Weston Lea Ltd

HD712 – Amberfield – peer review of the liquefaction assessment

Weston Lea Ltd have engaged HD Geo to undertake a geotechnical peer review of the liquefaction assessment that ENGEO prepared as part of their Geotechnical Investigation Report for the subdivision. In this letter, we have presented the findings of the review and provided recommendations.

GEOTECHNICAL CONSTRAINTS PLAN
- PROPOSED CONTOURS

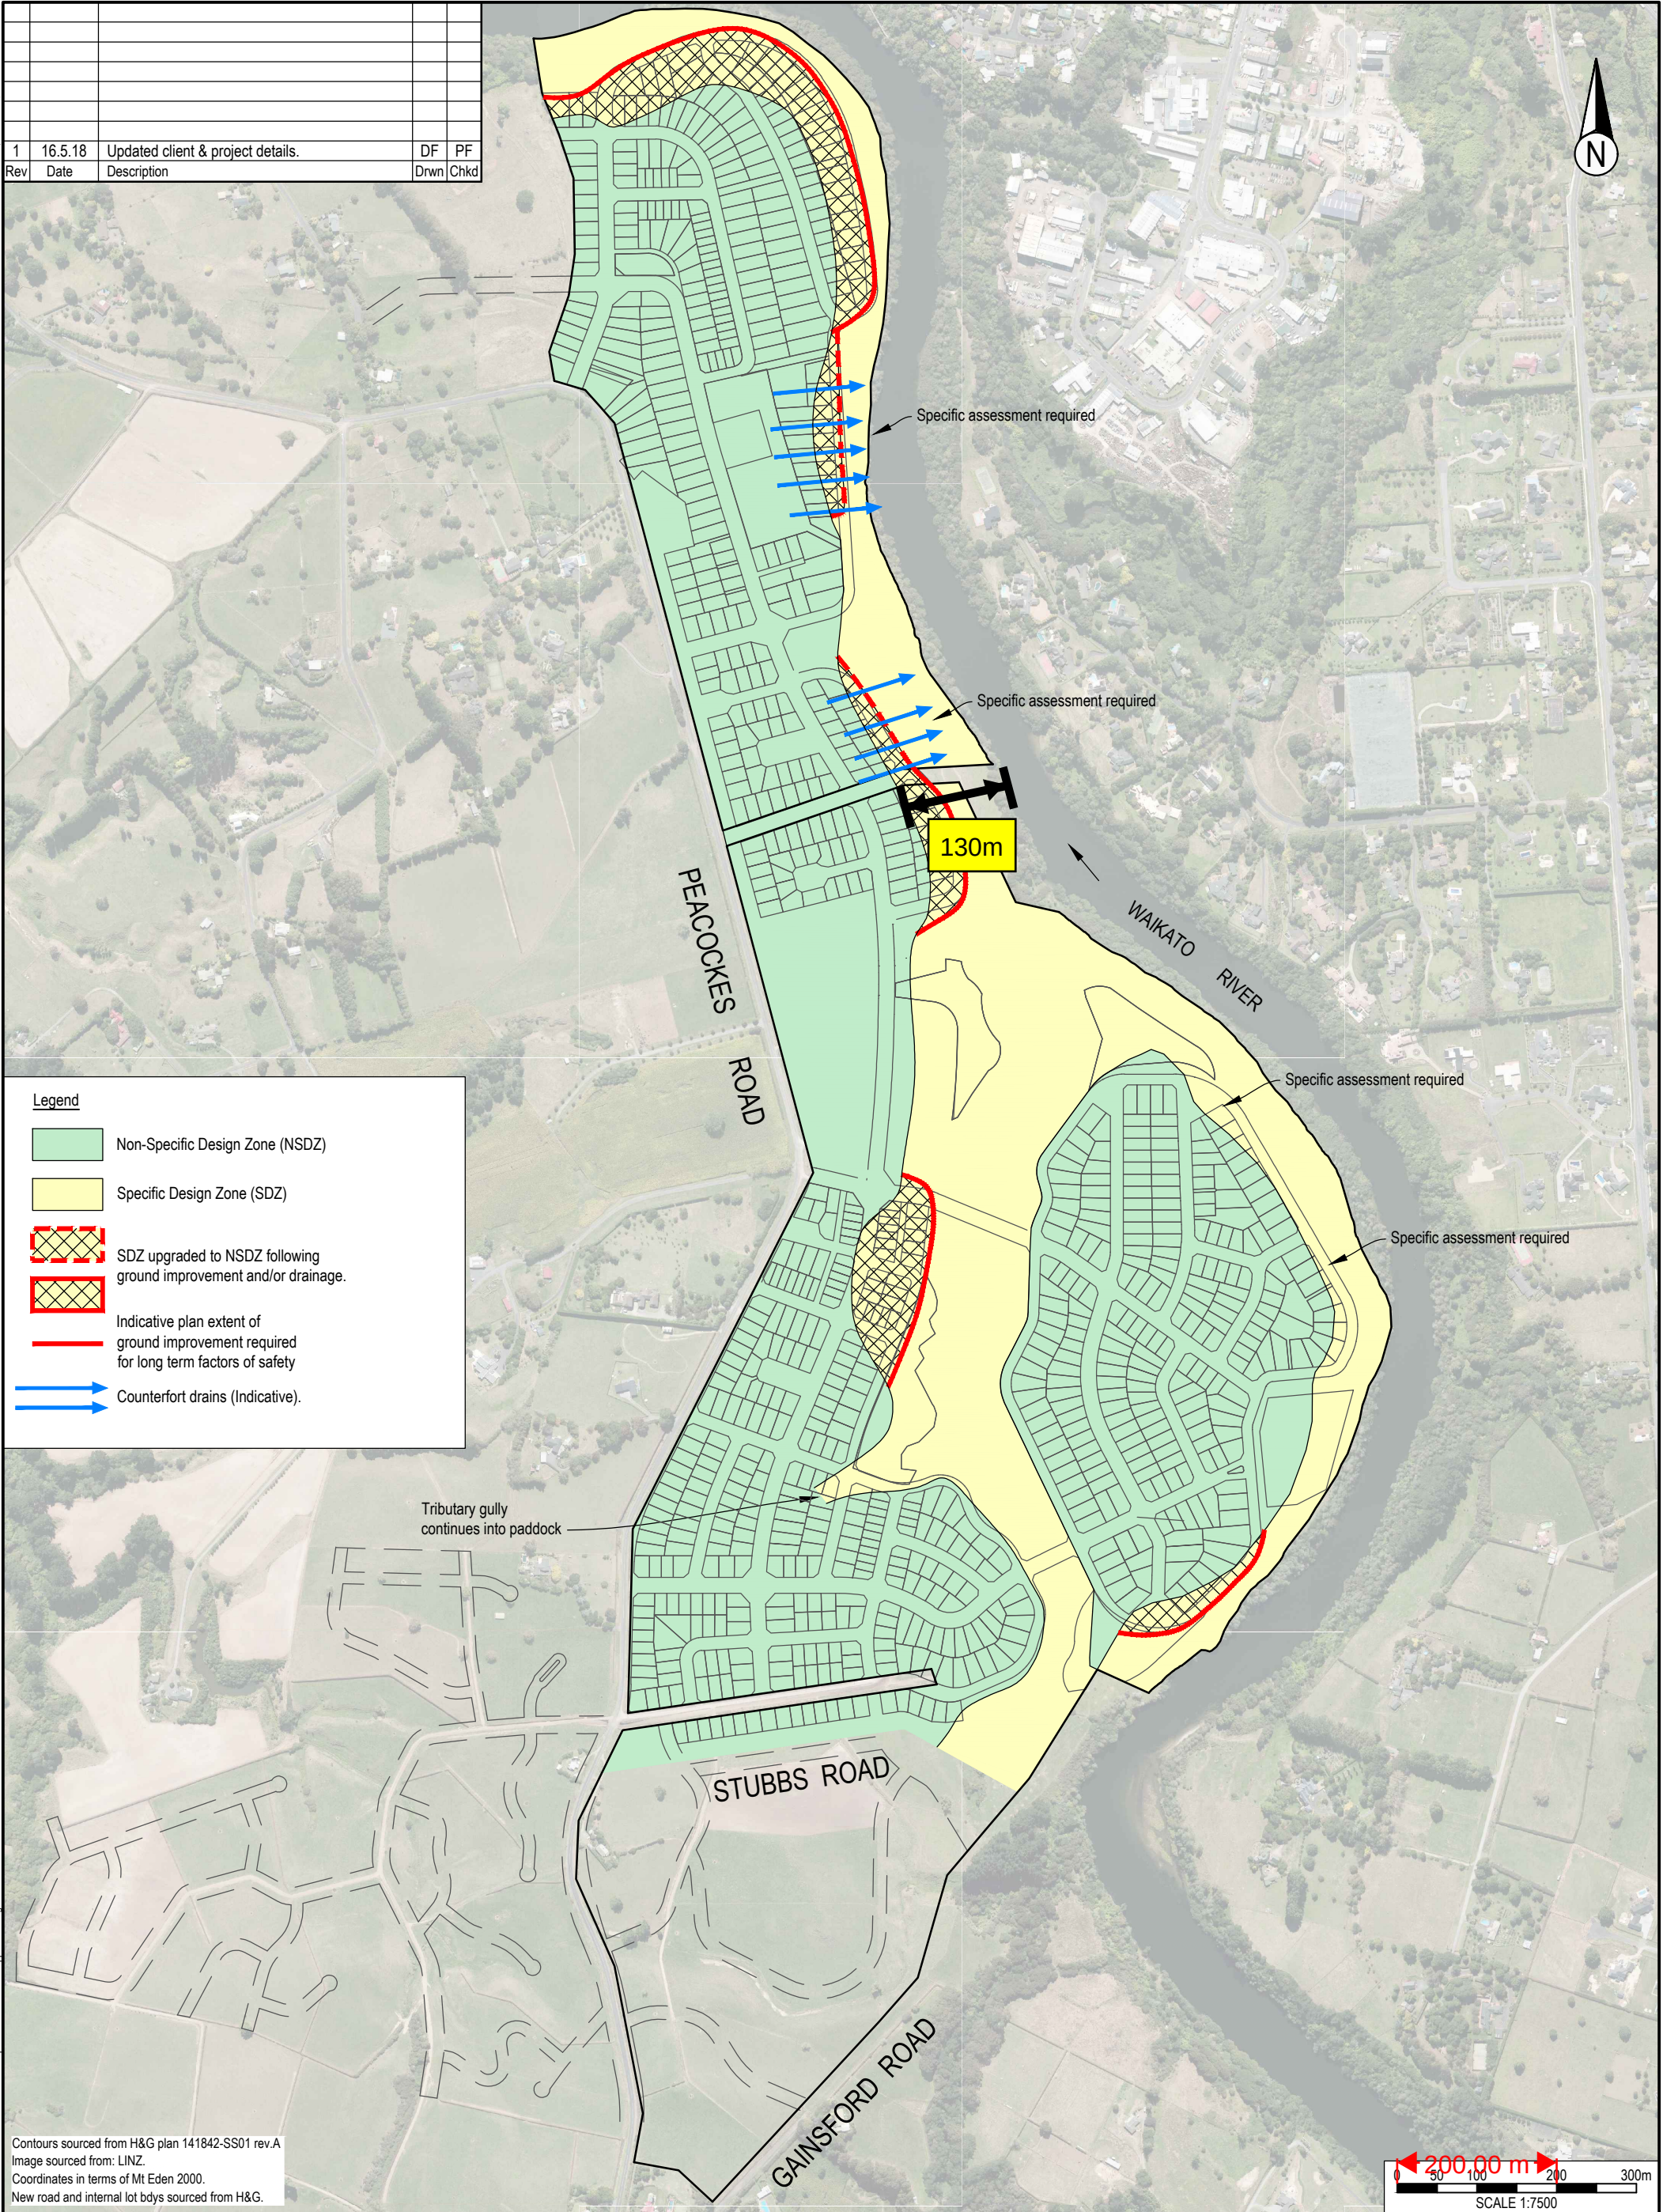
HD Geo 5	The current 'geotechnical constraints' plans are limited to the impact of slope stability. Consider re-naming the plans to reflect the hazard that they cover and present another plan that shows the liquefaction hazard.	Liquefaction hazard now shown on plans	Liquefaction hazard plans reviewed. Approach shows areas where additional assessment should be focused to define areas needing mitigation/special considerations for development.
HD Geo 6	Slope stability modelling looks at seismic acceleration applied to the ground models but does not consider a post earthquake, liquefied case. Has consideration been given to assessing lateral spreading this way?	The risk of liquefaction is considered low as per the revised analyses. Updated stability modelling shows anticipated instability related to liquefied layers matches closely with currently presented constraints plan.	Analyses have been reviewed. The existing constraints plan appears to cover the potential extent of liquefaction related instability. No further work required for suitability stage – recommendations for refining areas and mitigation needed as above.
